Access Compliance Report

Public Rights-of-Way

(Curb Ramps)

Intersection ID: 8925	Main Street: E_W_T_HARRIS_BV	Cross Street: THE_PLAZA	Location: NW
ADA ID: 13FA8699FF58	Ramp Type: Directional1	Initial Pass/Fail: Pass	Overall Compliance: No
Severity Score: 0			
Codes/Mitigation Info/Possible Solution		Field Measurements/Component Compliance

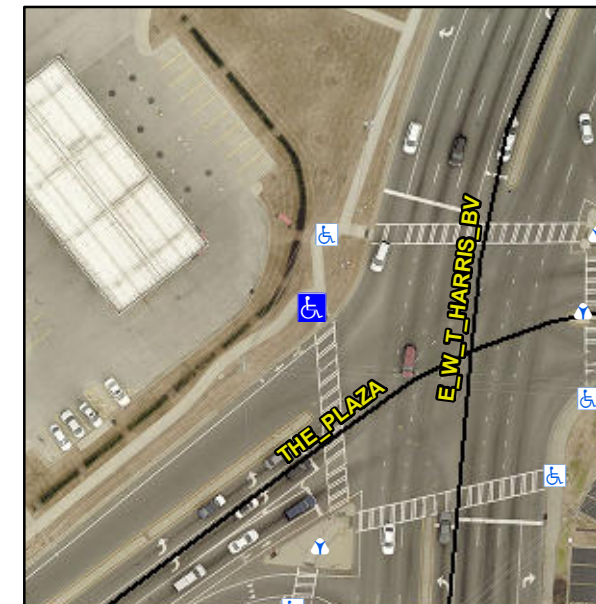
**R304.2.2-Perp, R304.3.2-Para,
R304.5.3, R302.7**

Compliance	Description	Data	Compliance	Description	Data
N/A	Ramp Length (in)	83.0	Yes	Grade Break?	Yes
Yes	Ramp Width (in)	71.0	No	Grade Break Slope (%)	6.4
Yes	Ramp Slope (%)	8.2	Yes	Grade Break XSlope (%)	1.2
Yes	Ramp XSlope (%)	0.3			
Yes	Flare Type LT	N/A	Yes	Flare Type RT	N/A
N/A	Flare Slope LT (%)	N/A	N/A	Flare Slope RT (%)	N/A
N/A	Flare Traversable LT?	No	N/A	Flare Traversable RT?	No
Yes	Landing Length (in)	60.0	Yes	DWS Provided?	Yes
Yes	Landing Width (in)	72.0	Yes	DWS Contrast?	Yes
No	Landing Slope (%)	2.1	Yes	DWS Length (in)	24.0
Yes	Landing X Slope (%)	0.6	Yes	DWS Full Width?	Yes
N/A	Landing Curb? (Y/N)	N/A	Yes	DWS Offset LT (in)	32.0
N/A	Shared Landing?	No	Yes	DWS Offset RT (in)	0.0
No	Gutter Ponding?	Yes	Yes	Gutter Slope (%)	3.3
Yes	Gutter Lip Ht (in)	0.0	No	Gutter X Slope (%)	3.2
N/A	Painted X Walk1?	Yes		Road Slope (%)	2.2
	X Walk 1 Direction	To S		Road X Slope (%)	2.4
	X Walk 1 Width (in)	134.0		Clear Space?	Yes

**Remove & Replace Entire Ramp.
Remove & Replace Gutter.**
